**Report: Deficiency Report**  
**Function: Test, Adjust, & Balance**  
**Date: 04/08/2024**

**PROJECT**  
**04-01-24 CHUY'S - MUELLER, TX**

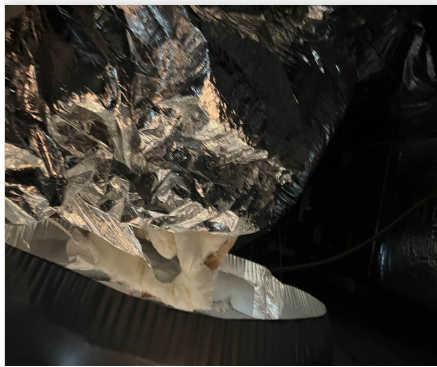
**Issue Name :** AHU-5 No Accessible Balance Dampers  
**Description :** No volume dampers could be located on the AHU-5 supply ductwork. As a result only the unit total has been set.  
**Created By :** National TAB                      **Assigned To :** National TAB - Will Turnbough  
**Status :** Open  
**Priority :** Urgent                                      **Asset Tag :**  
**Originated Date :** 04/09/2024 - Stephen Tassinaro - National TAB

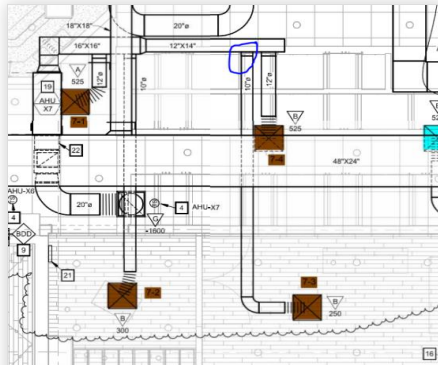
**Issue Name :** Diffuser 11-3 Damaged  
**Description :** Diffuser 11-3 is damaged and the perforated cover is falling off as a result. NTi reinstalled the cover several times throughout the day. Recommend repair/replacement.  
**Created By :** National TAB                      **Assigned To :** National TAB - Will Turnbough  
**Status :** Open  
**Priority :** Low                                      **Asset Tag :**  
**Originated Date :** 04/08/2024 - Stephen Tassinaro - National TAB
